The Graduate Austin

Design Commission

December 11, 2023

Working Group Recommendations 11/8/2023

B5: Control On-Site Parking

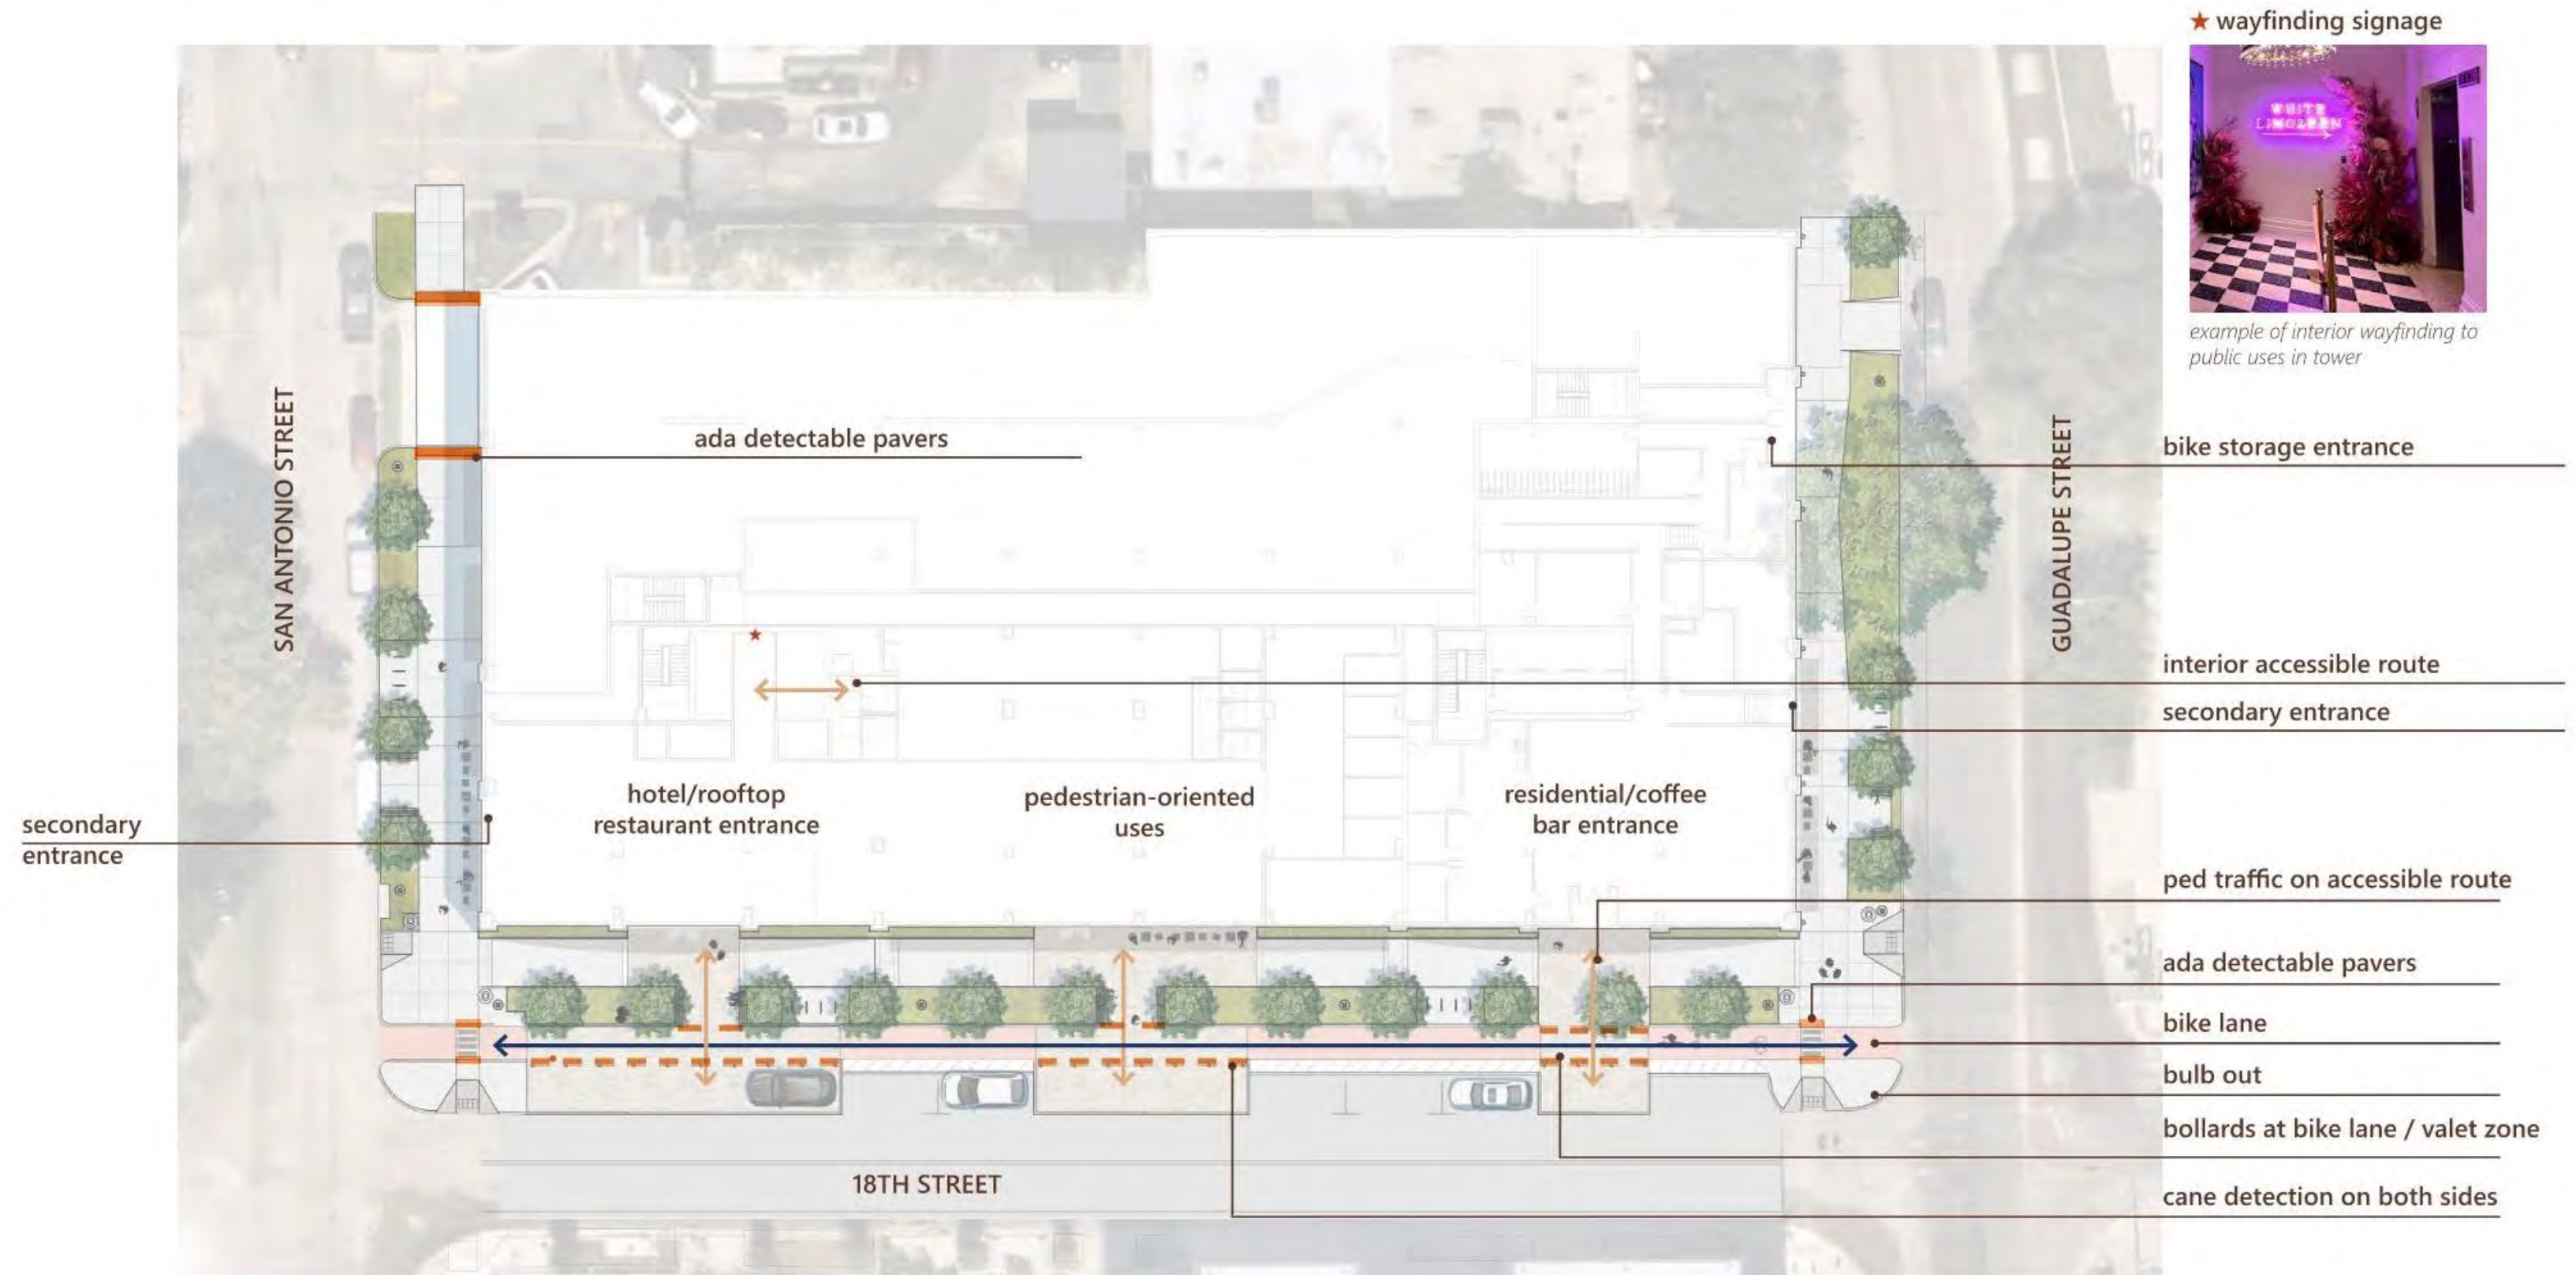
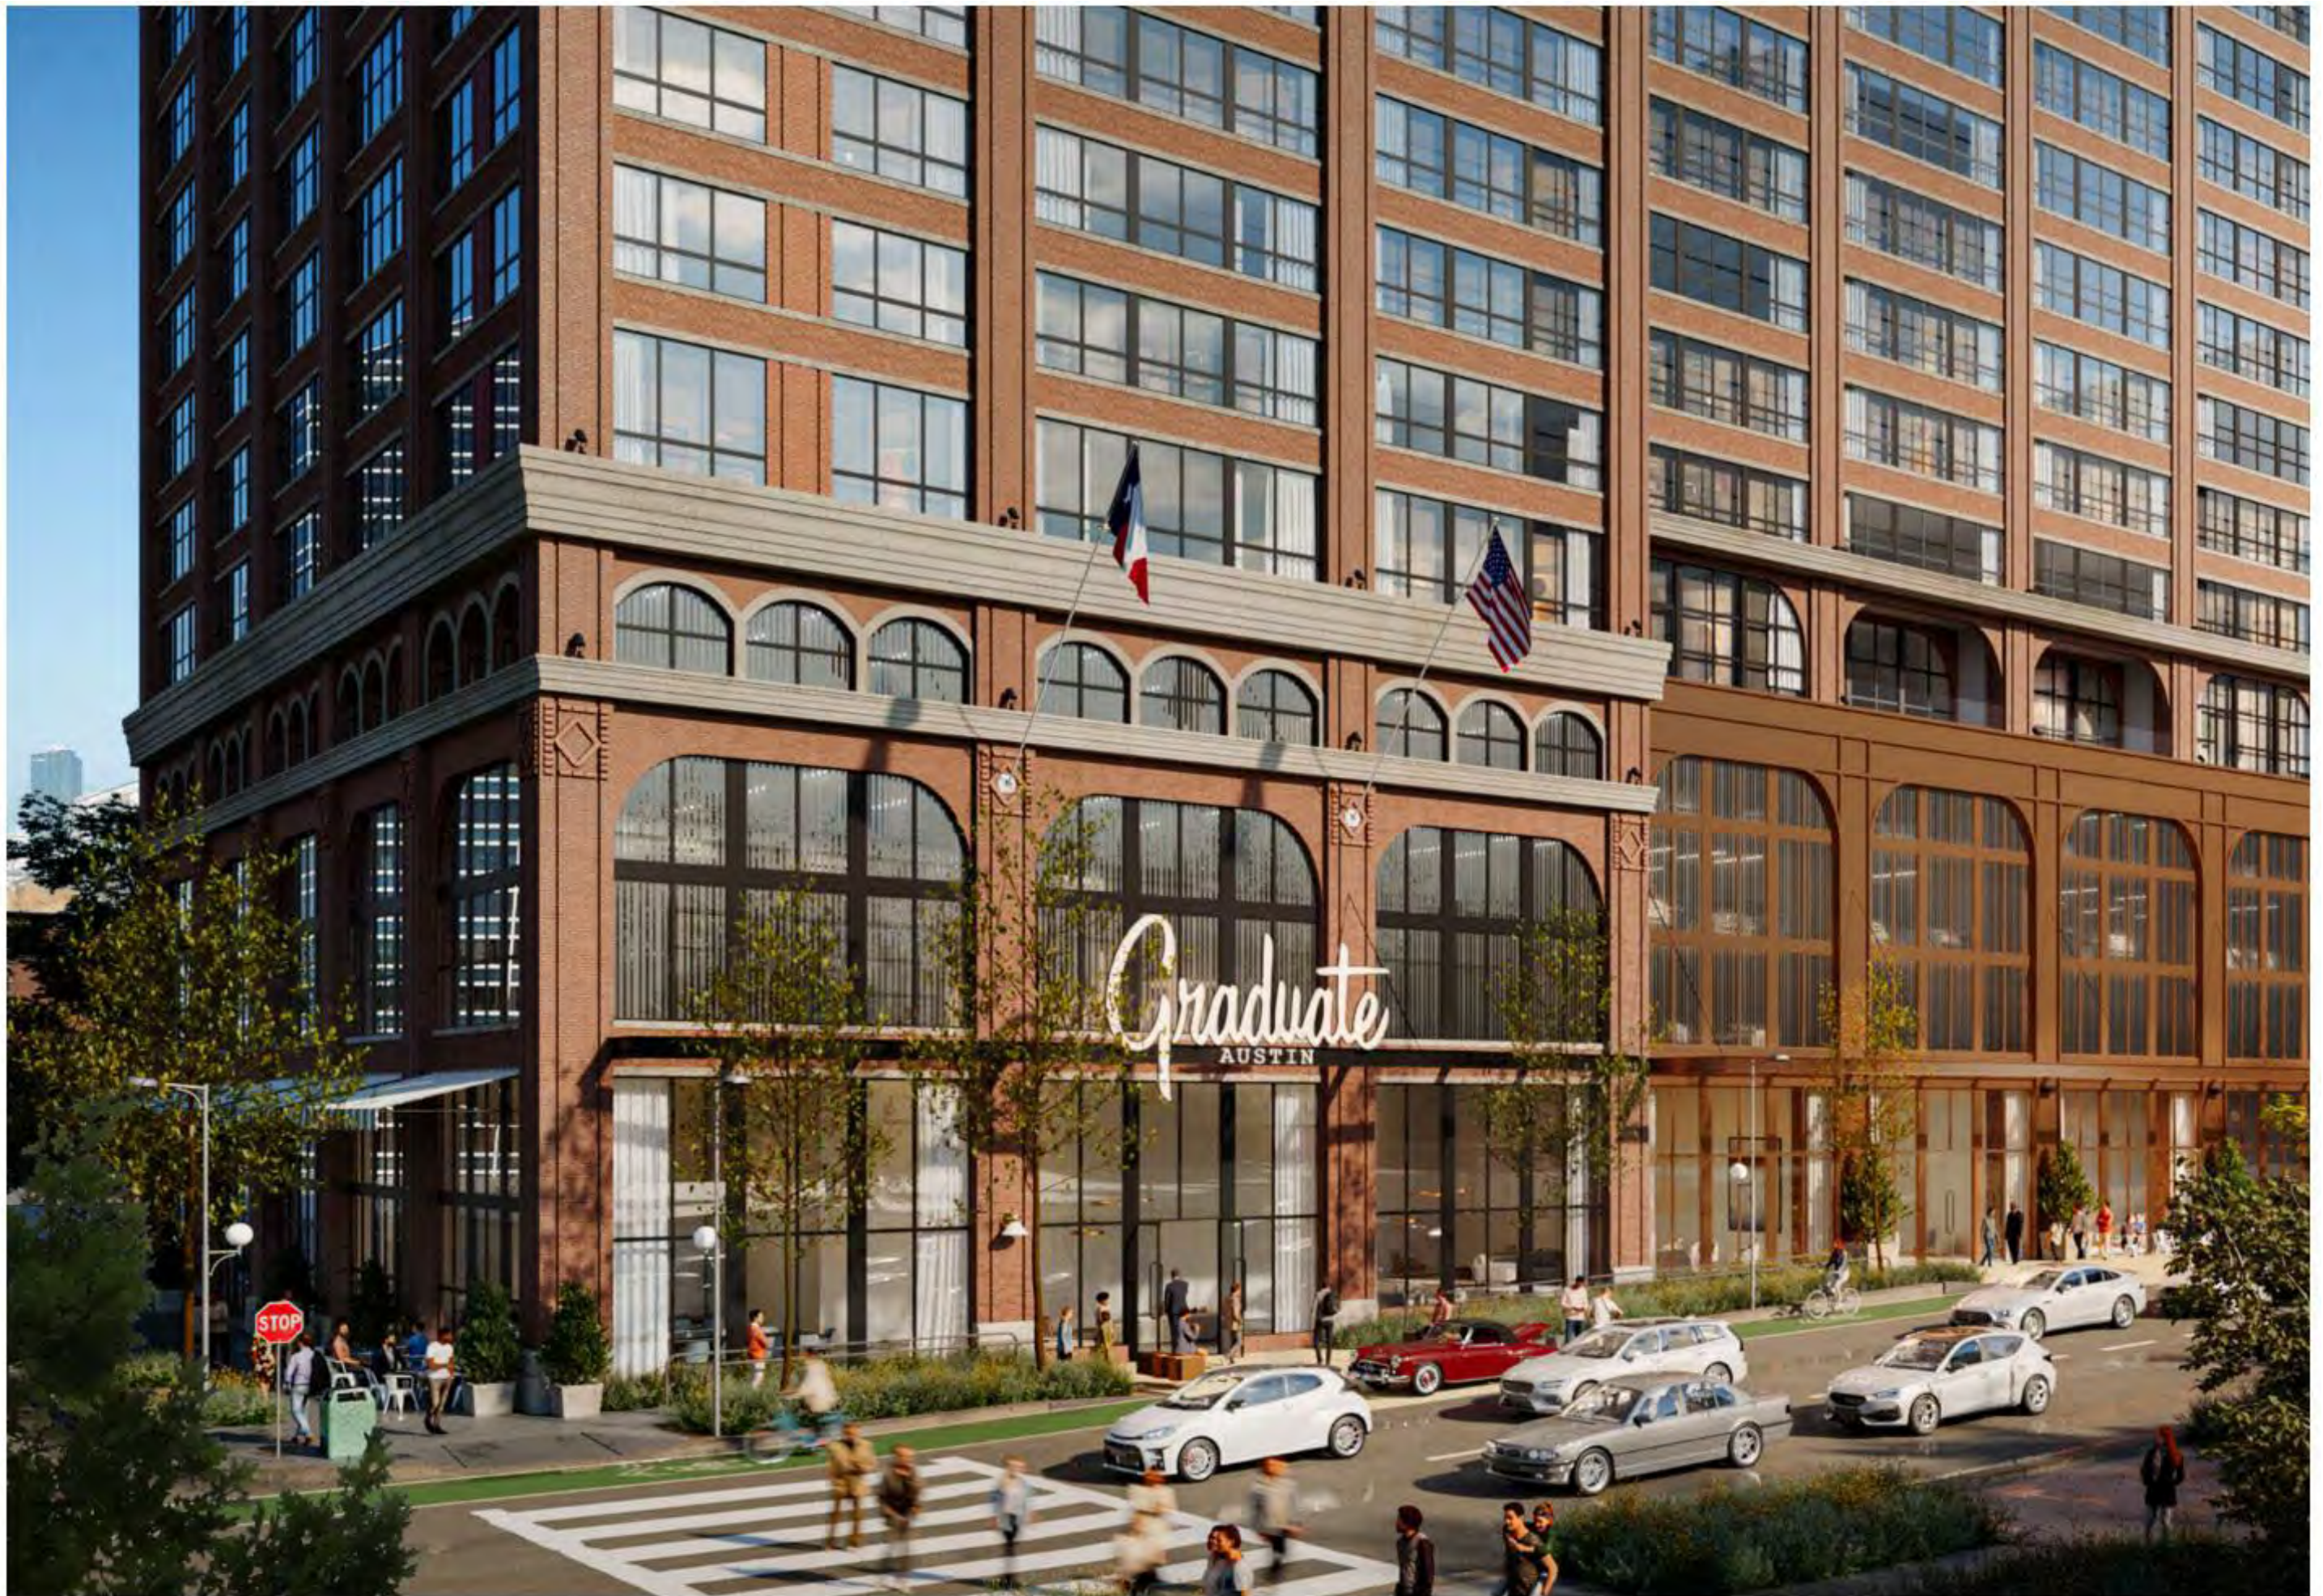
Urban Design Guideline	Working Group Recommendation
B 5: Control On-Site Parking	Refer to PS.10 comment above.

streetscape design

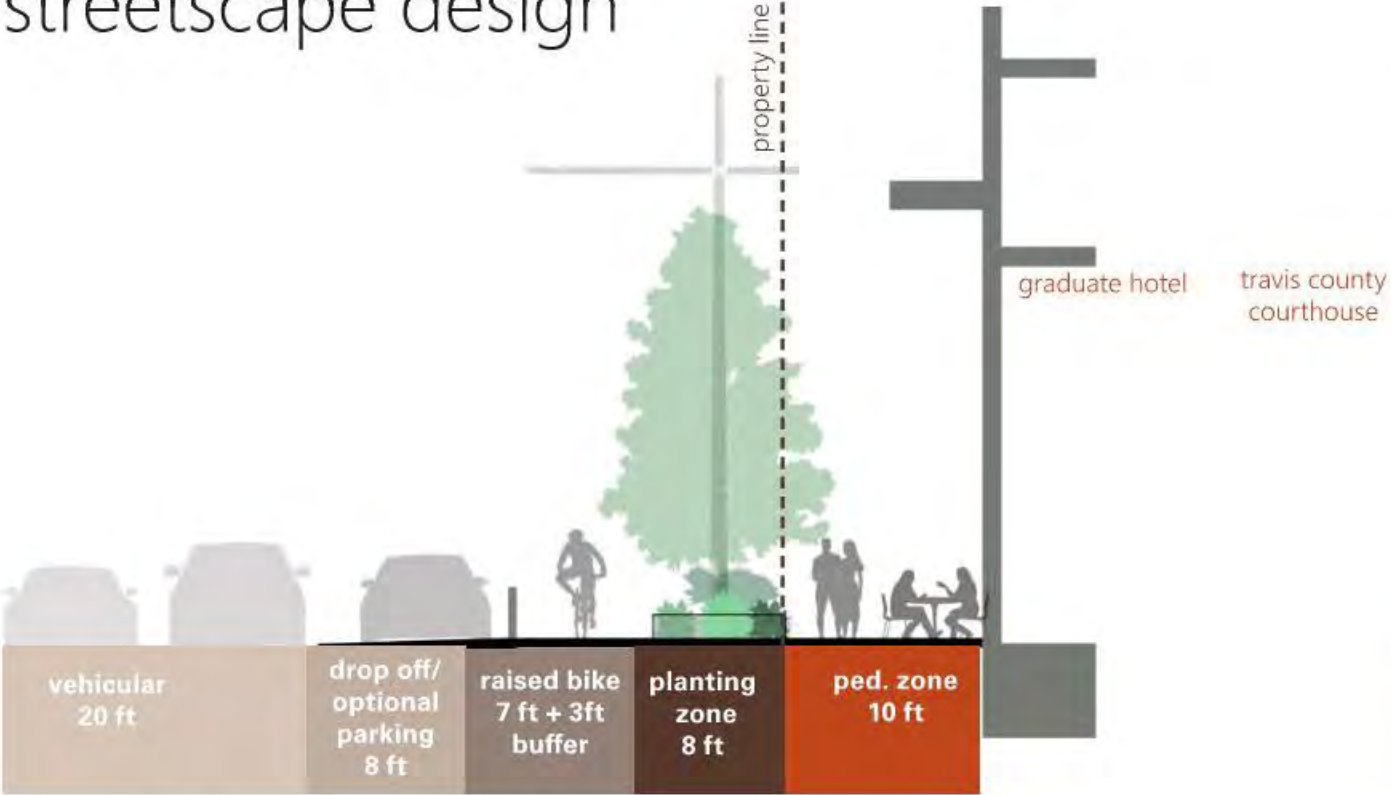
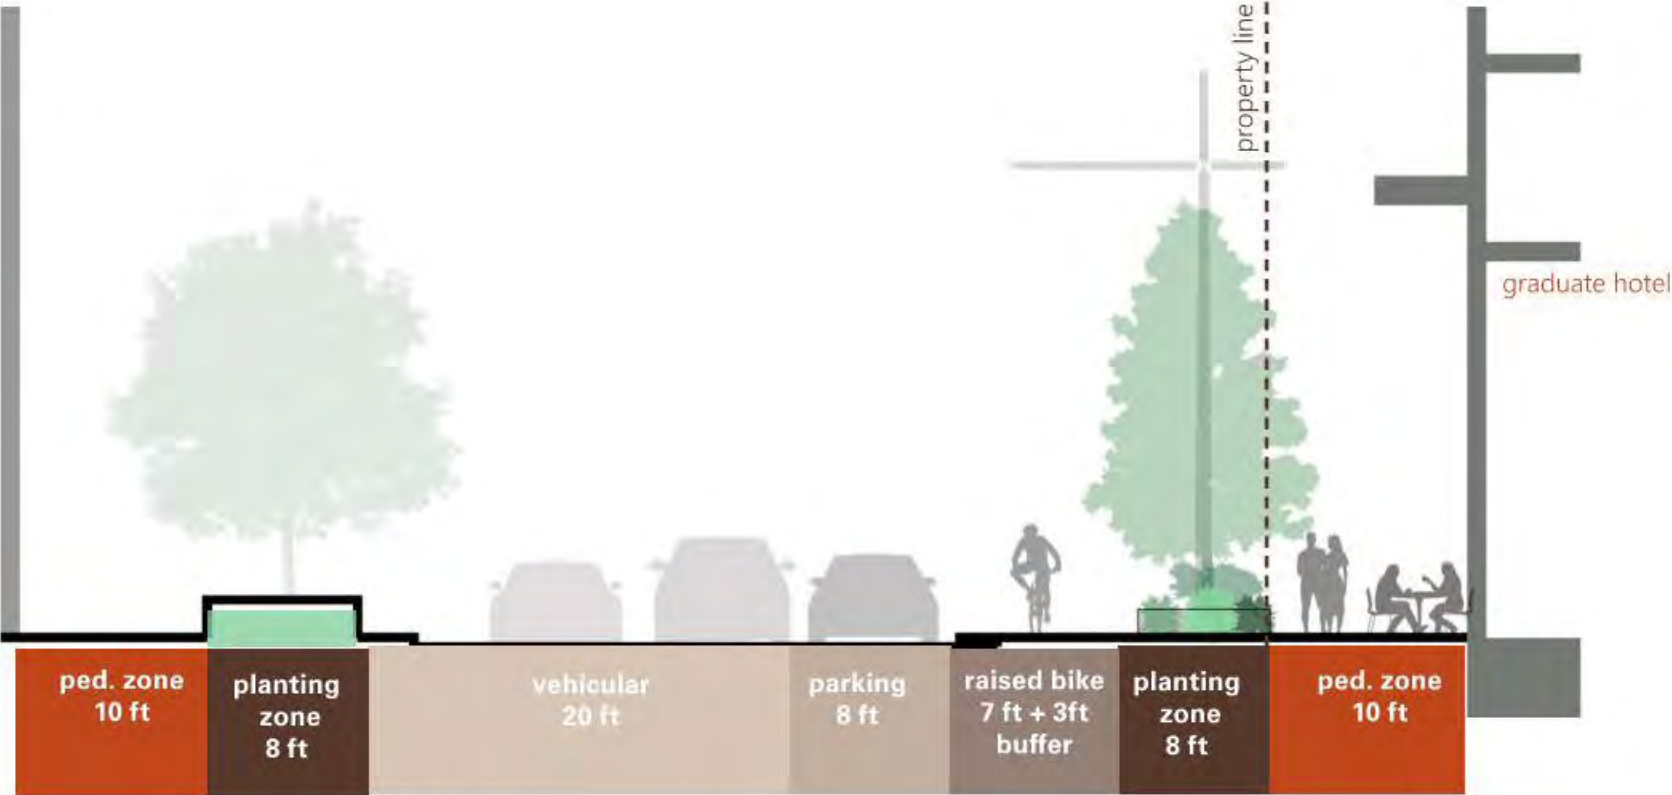
Urban Design Guideline	Working Group Recommendation
PS 1: Protect the Pedestrian Where the Building Meets the Street	Provide more information at both San Antonio and Guadalupe streets for the street plazas, at the parking garage entry and address how pedestrian will be protected walk across driveway.
PS 10: Provide Protection From Cars/Promote Curbside Parking	Protect cyclist at raised curb drop-off by preventing vehicles from encroaching into bike lanes.
PS 12: Provide Generous Street-Level Windows	Generous windows provided however, large portions of windows along San Antonio and Guadalupe are within loading and back of house areas. Applicant is encouraged to provide activated uses behind these large windows.
PZ 5: Develop Green Roofs	No green roofs proposed for this project.
PZ 7: Determine Plaza Function, Size and Activity	Street plazas appear to meet great street standards, however no connection to the interior activated uses exists. Tables and chairs do not directly connect or correlate to any interior use.
